SEWAGE DISPOSAL SYSTEM HOWARD COUNTY HEALTH DEPARTMENT BUREAU OF ENVIRONMENTAL HEALTH 410-313-2640

A REPAIR

SUBDIVISION Daisy Hill Estates LOT NUMBER .5 ADDRESS 15884 Union Chapel Road

Date:	10/17/00
Drawn By:	DDE
Checked By:	DDE
Project No.:	ADD
Project:	ENDERS RESIDENCE ADDITION 15884 UNION CHAPEL ROAD, WOODBINE, MD LOT 5, DAISSY HILLCRESTS
Client:	ENDERS FAMILY HOWARD COUNTY MARYLAND
Title:	PLOT PLAN 1.5 ACRES (65,840 SF)
Revisions	Mark Date By

PLOT

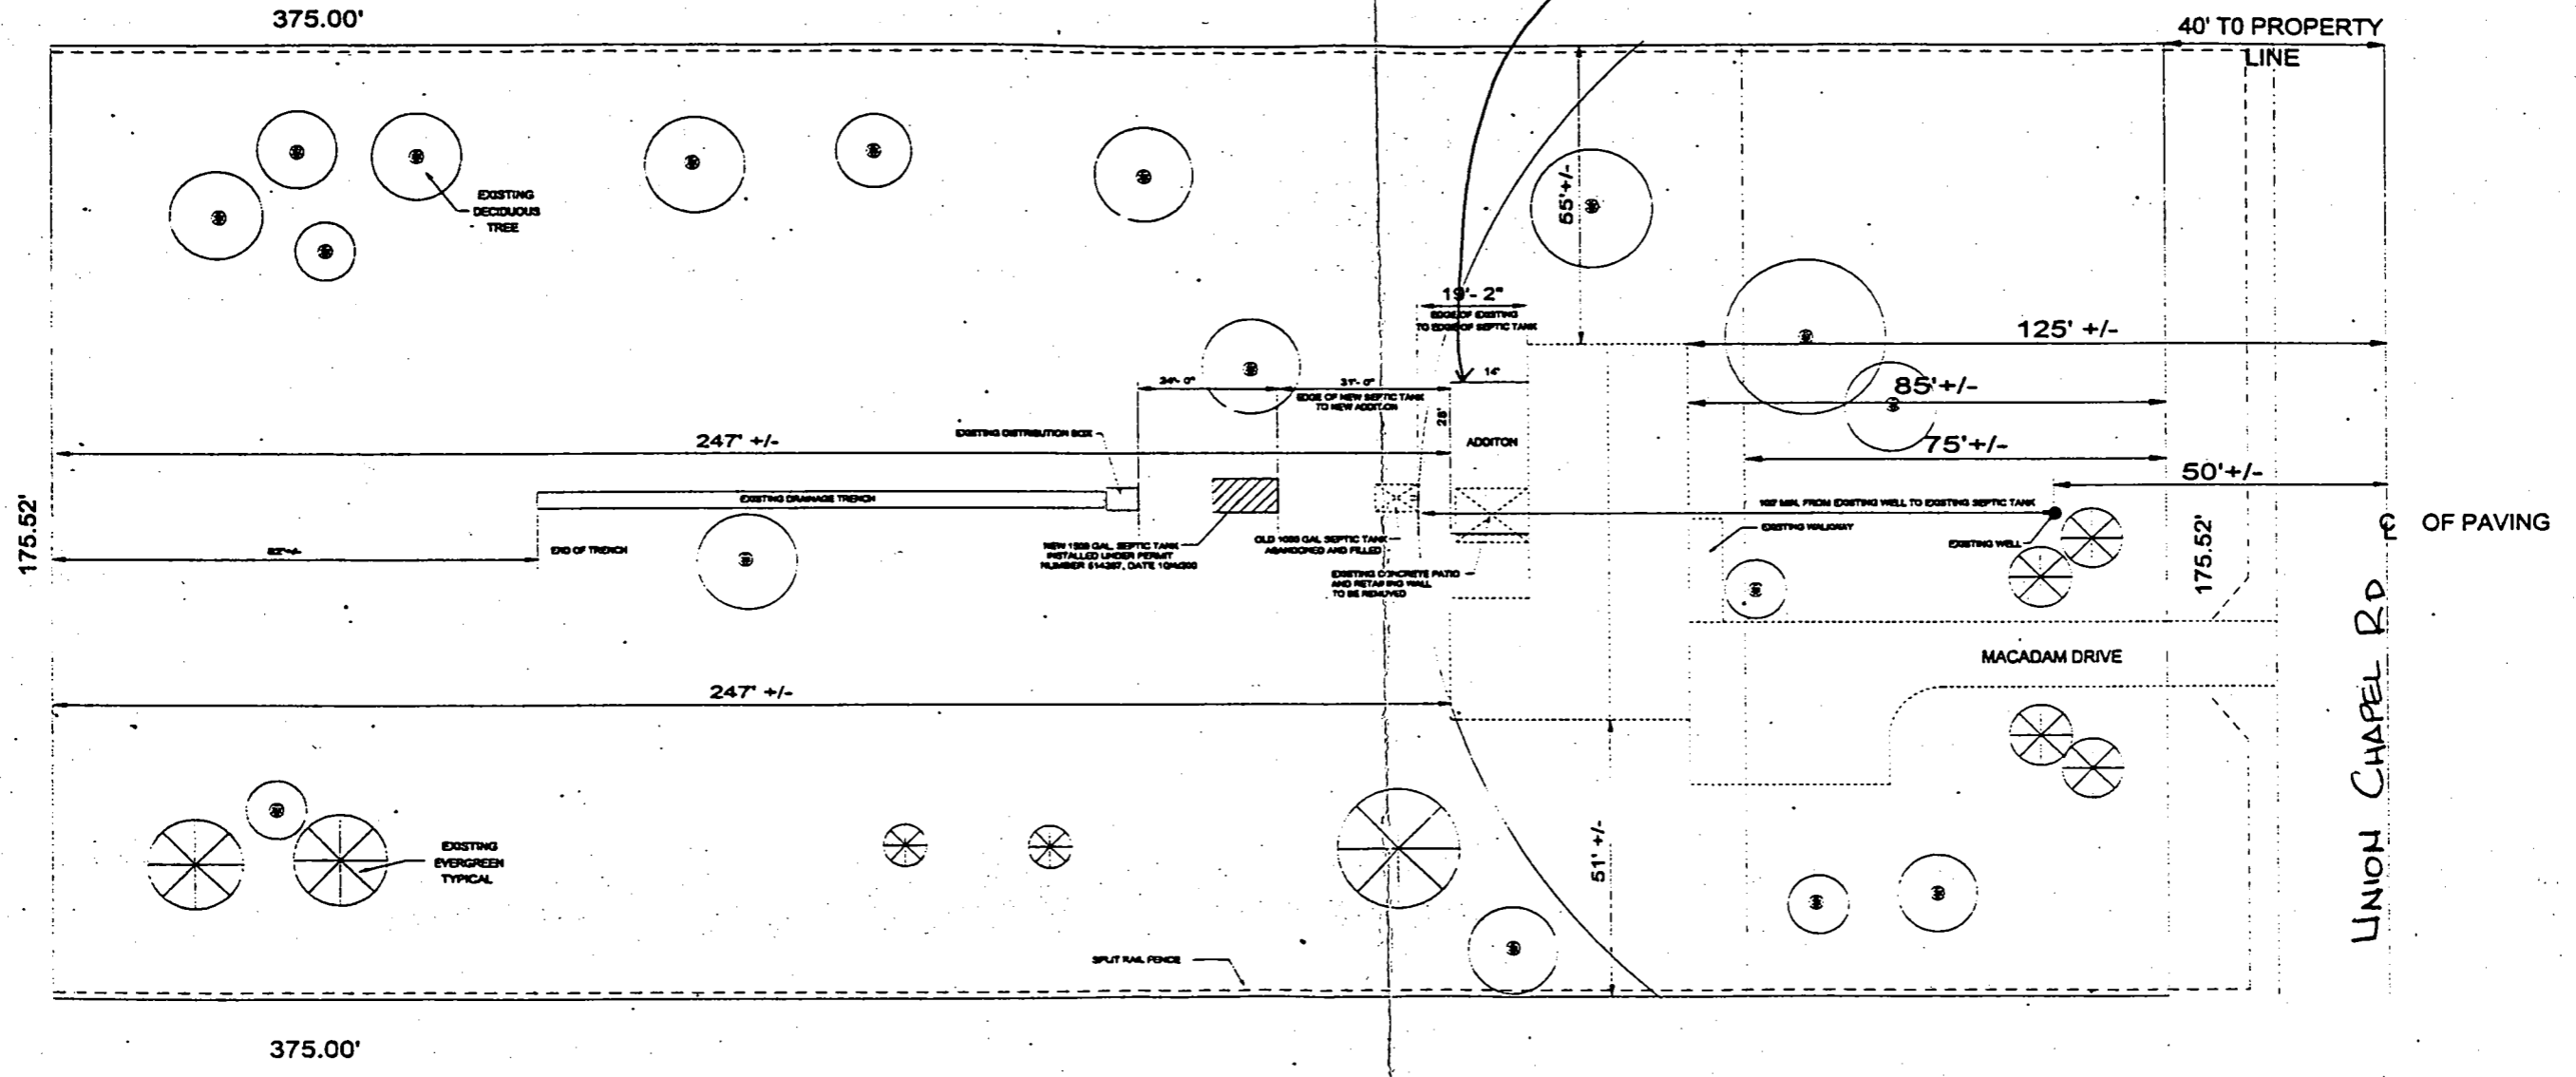
PRE-CONSTRUCTION INSPECTION: old drywell had no inspection clearance, excavated to hit then gravel on side of DW. was full of sewage water to top of lid. Owner claim's Fryck put in a repair septic trench, we have

INSPECTION COMMENTS: No record of this repair. (Mike & Fryck knew of this repair). Found clean dry gravel at Midway and @ end of repair trench, Excavated 14 ft deep 2 ft past end of gravel trench, No water seepage observed. Conclusion: Repair gravel trench is still in functional order. Only need replacement of Septic Tank and connecting pipe. OK to continue & cover all work when finished. April 11/10

Proposed addition has
no impact to well or septic
OK SRK 10/26/00

P 31306

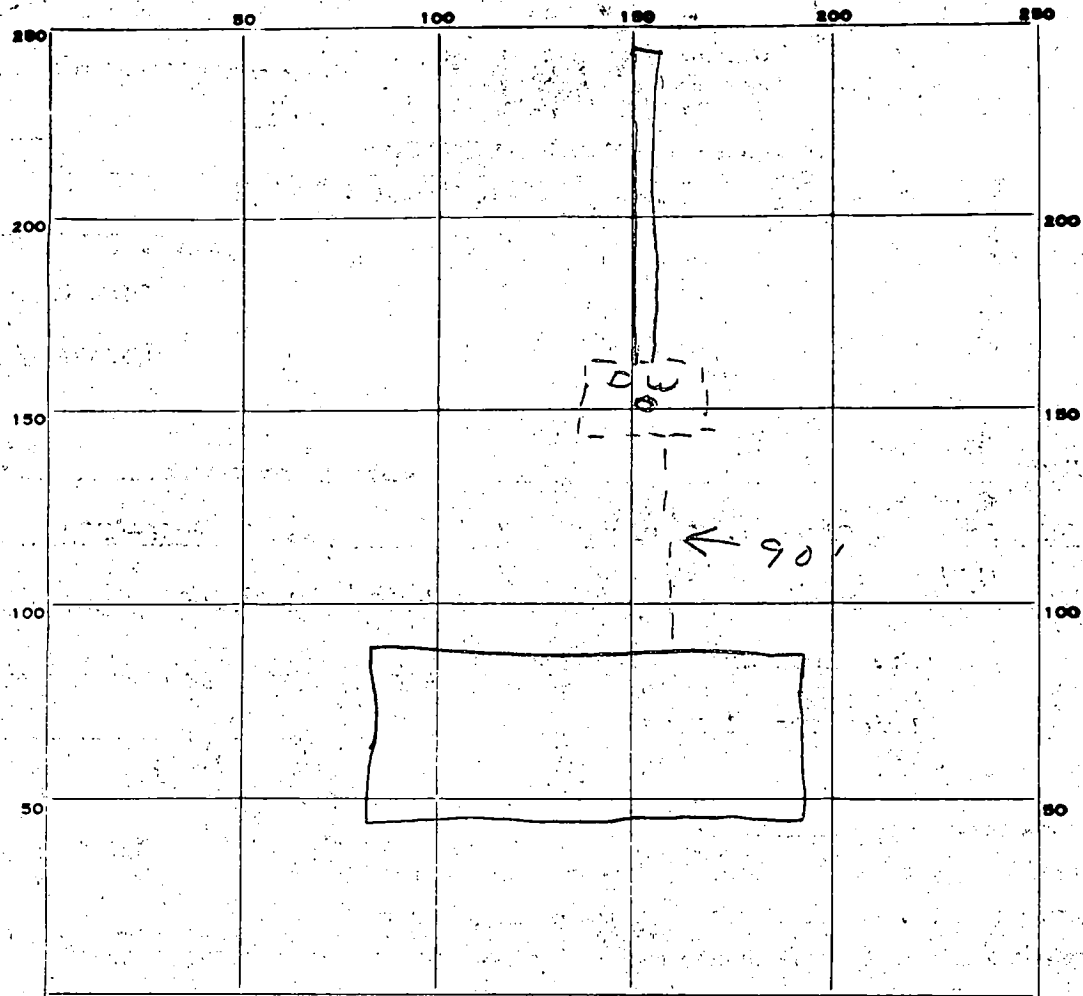
REpair - Call for inspection when ground is opened up so sanitarian can recommend repair.

Trench - 90' long, 12' deep, 8' gravel
Need 5' buffer from drywell to beginning of trench

REMARKS 4/8/81 OK to add gravel in trench. js
4/8/81 OK to cover all work. js

PLOT

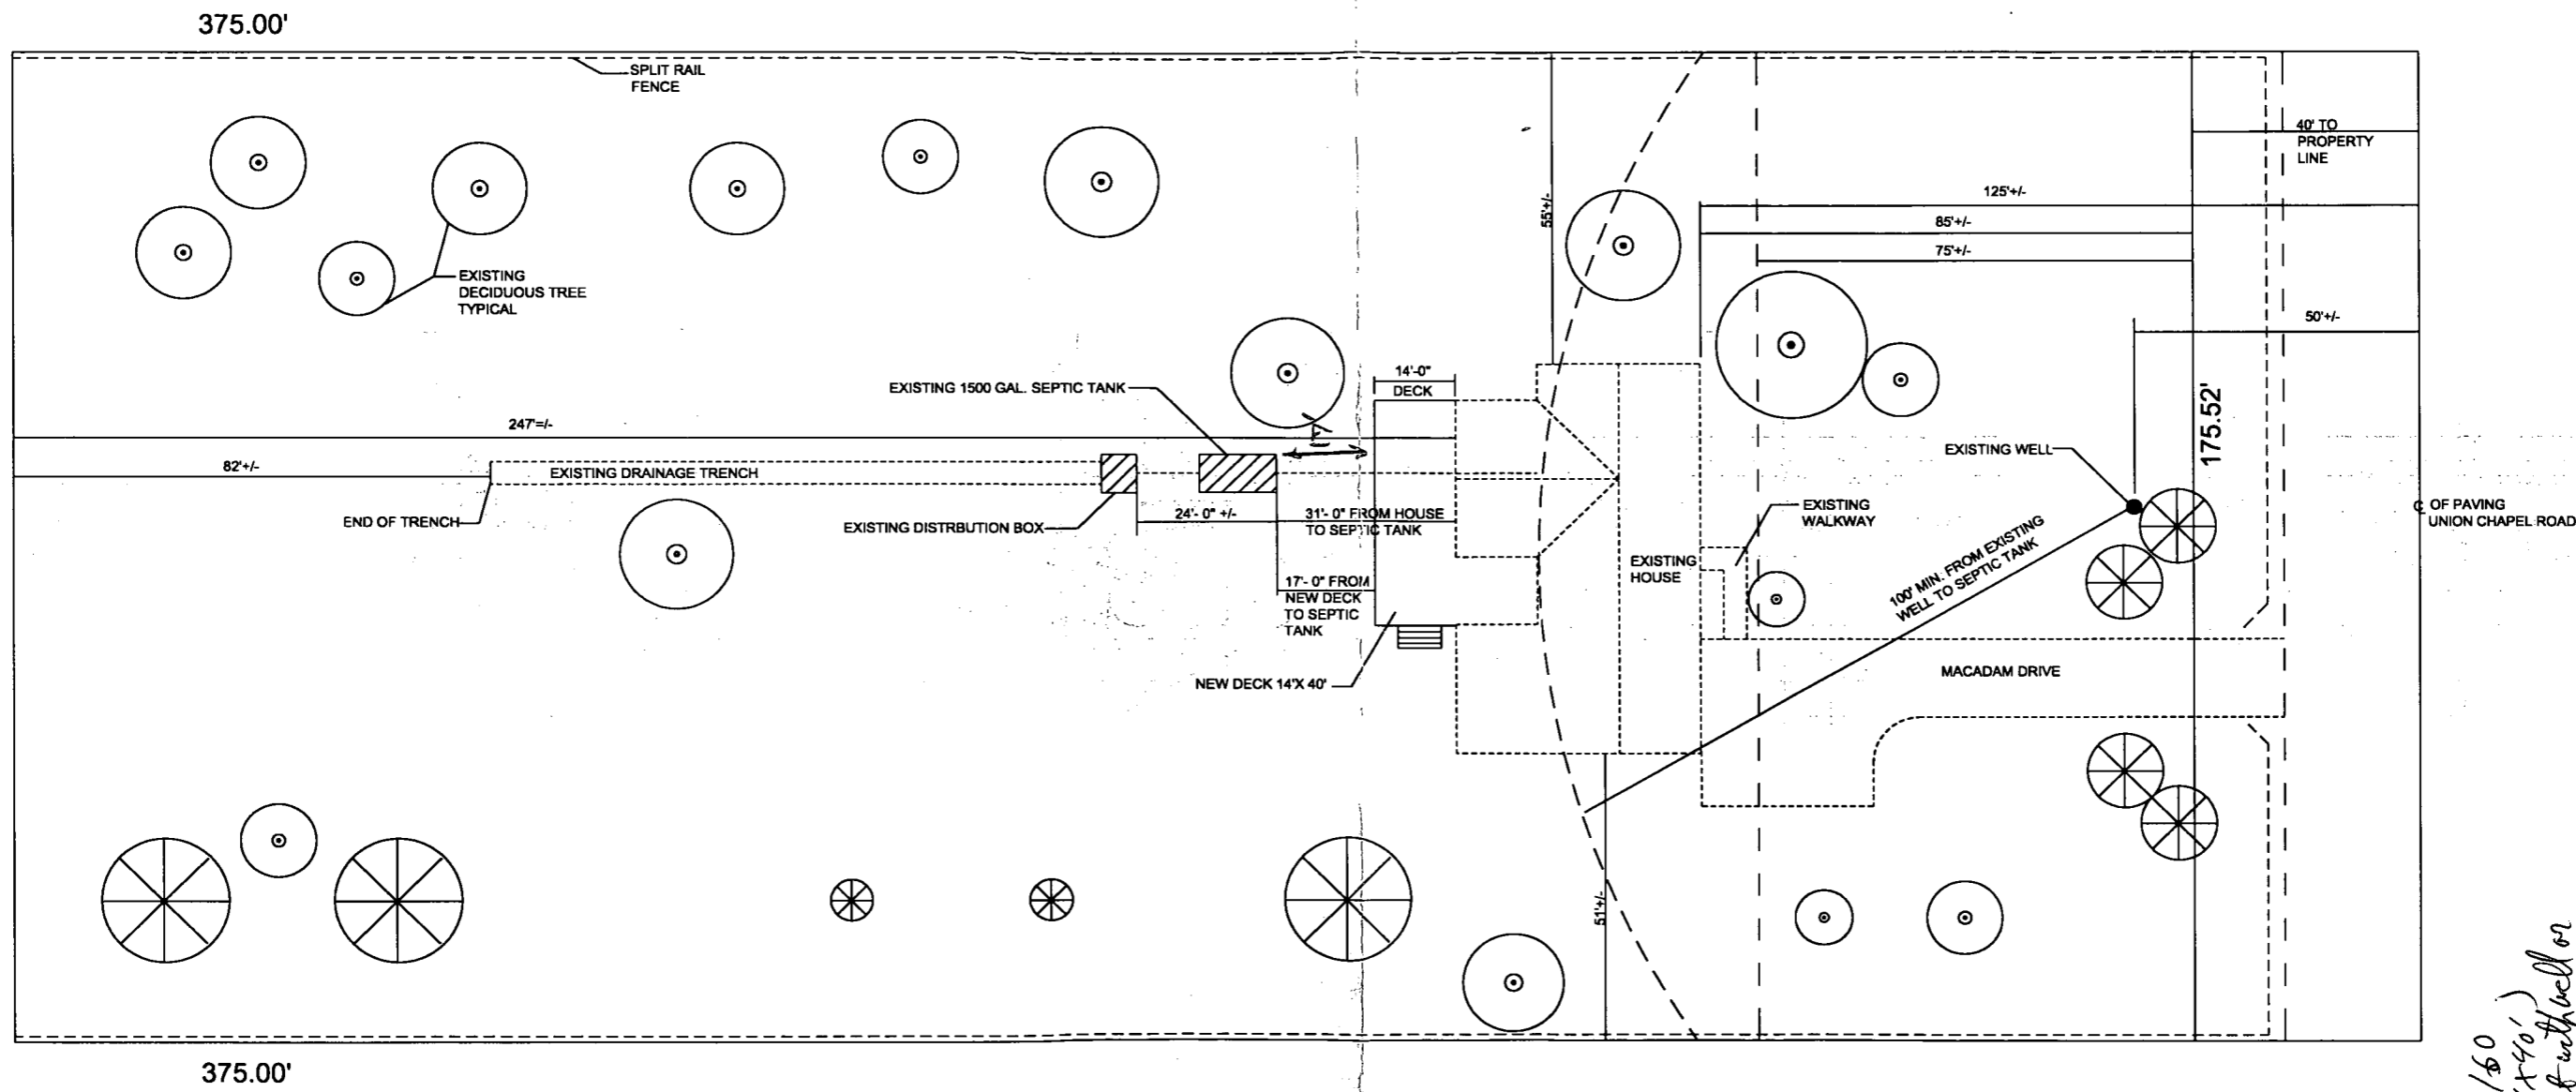
B 00135 / 60
 Deck (14x40')
 No Conflict with well or
 Septic. Recommend approval.
 AP 9/28/02
